# Woollahra Local Planning Panel (Public Meeting)

Thursday 7 March 2024  
1.00pm

## **LOCAL PLANNING PANEL DEVELOPMENT APPLICATION ASSESSMENT REPORT**

## SECOND FLOOR

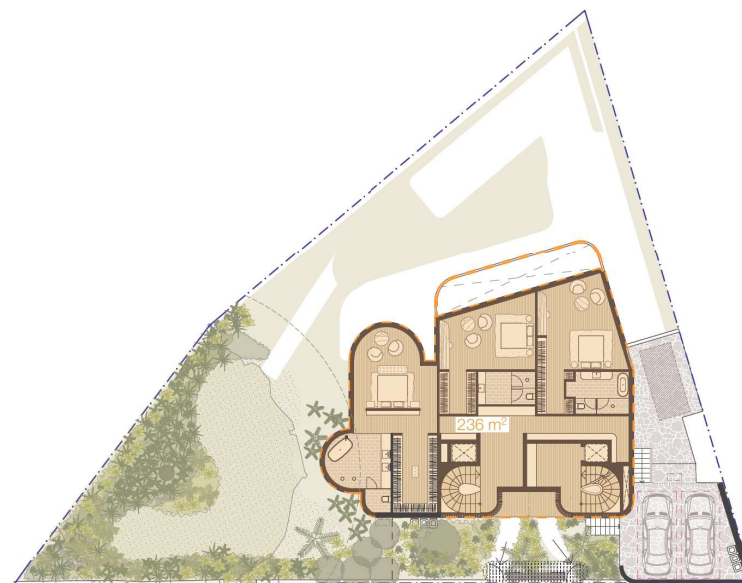
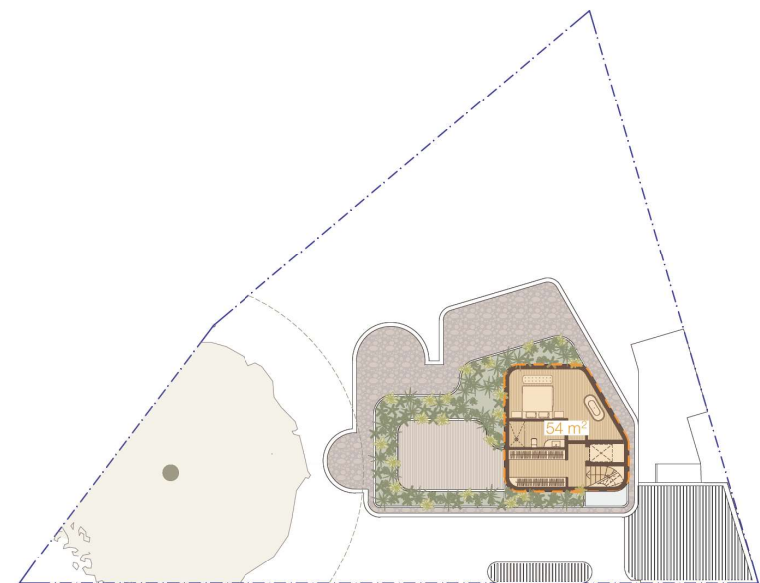
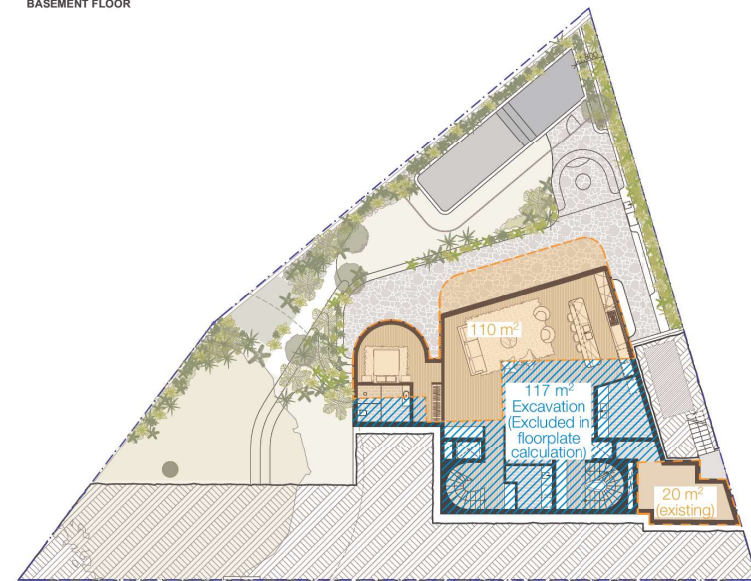
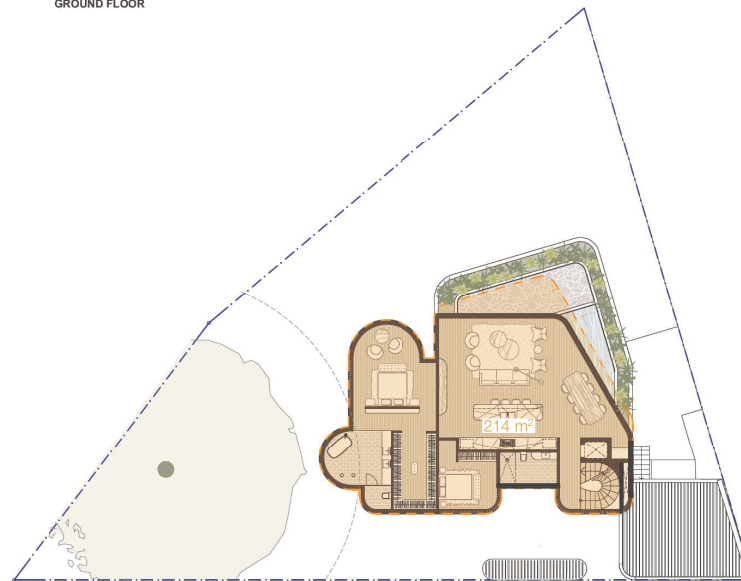
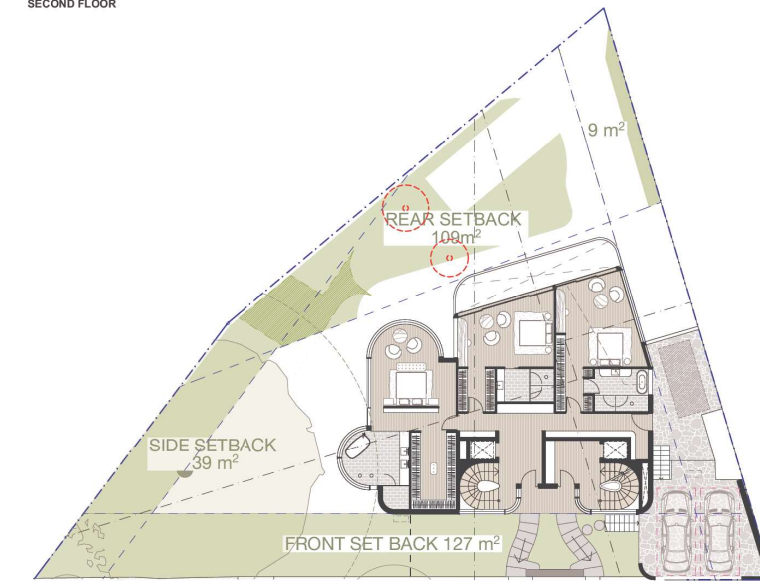
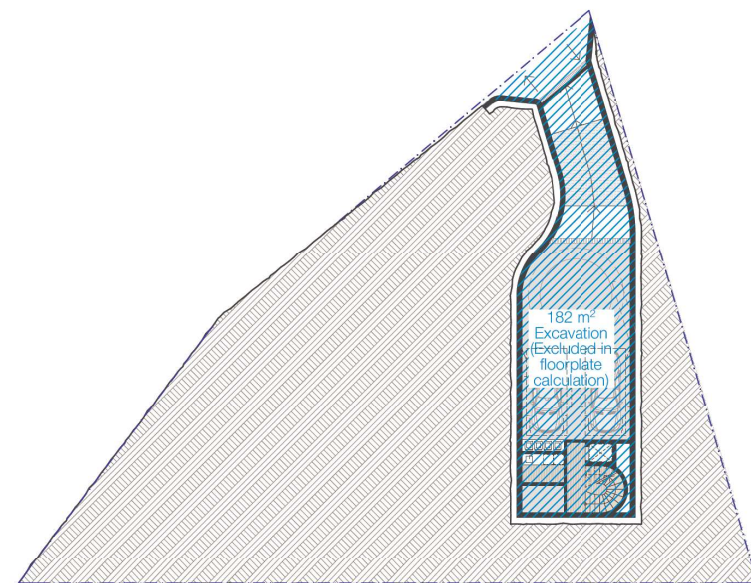
A skilful design regarding view sharing has not been employed.	The upper most level is to be deleted to ensure an acceptable view sharing impact. This will also result in a more positive design response in the context of the desired future character of the Vacluse West Residential Precinct.	14 and Condition C.1
Pruning of a tree has occurred since the original view assessment and a further more informed analysis should be undertaken given the changed context.	The upper most level is to be deleted as this is deemed to have an unacceptable view sharing impact. Therefore, the maximum height of the proposed dual occupancy would not rise above the existing maximum building height.	Condition C.1

Therefore, the upper most level is to be deleted via Condition C.1. Although this would result in a three storey form, this would have a more positive response to the surrounding development context verses the proposed four storey presentation.

Level 1 Landscape Plan

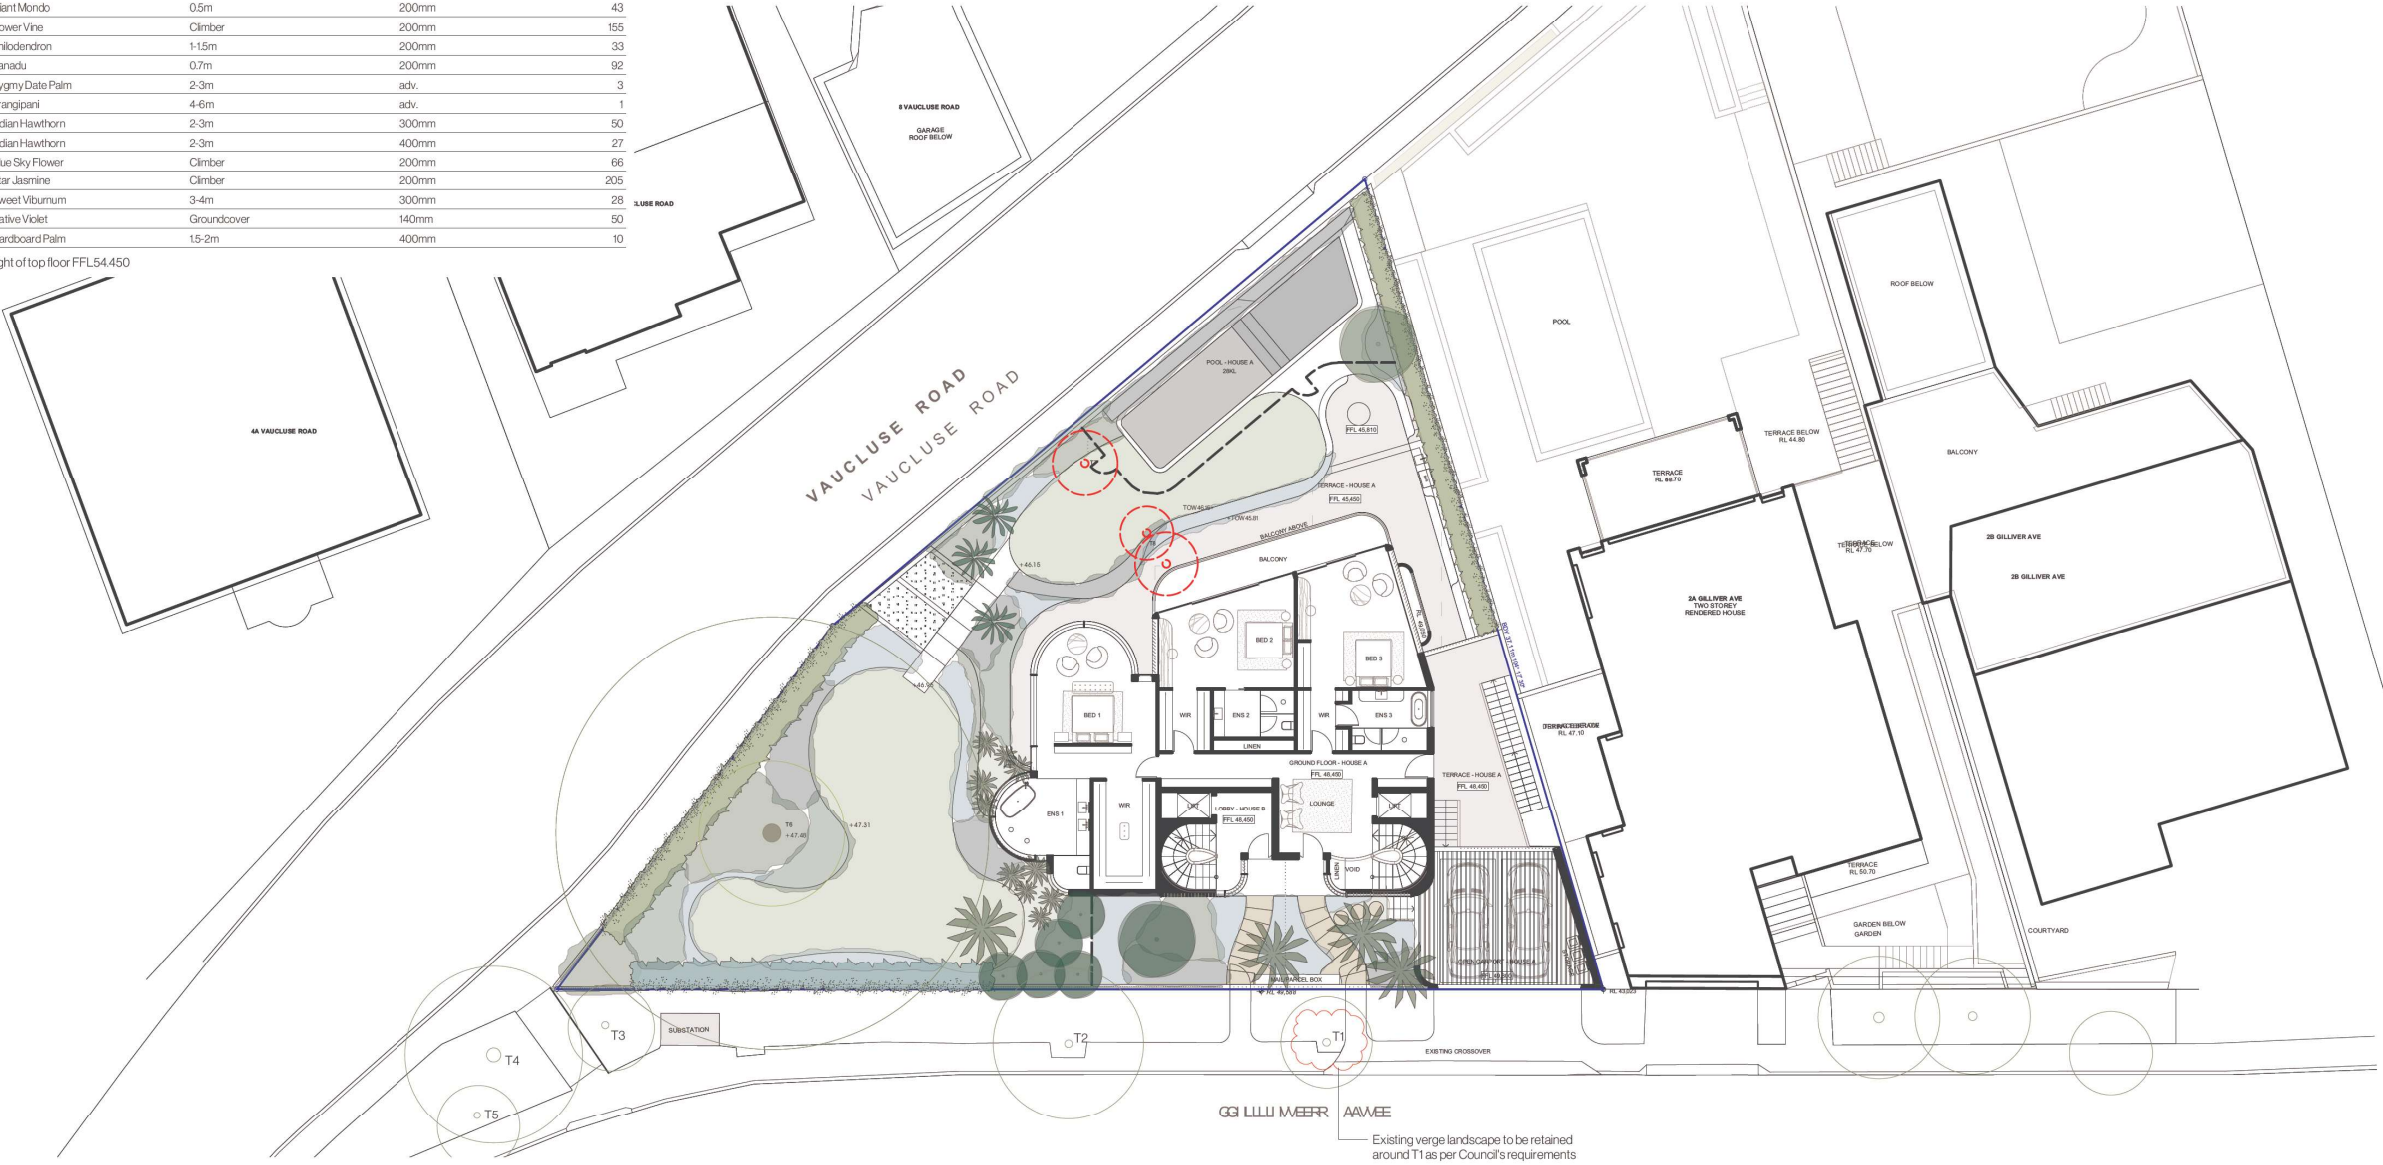
Landscape Plan does not comply with the following Control of B3.7.1 *Landscaped area and private open space* of the DCP: C17 Native species are preferred, and landscape designs are encouraged to provide at least 50% of the plants as native species.
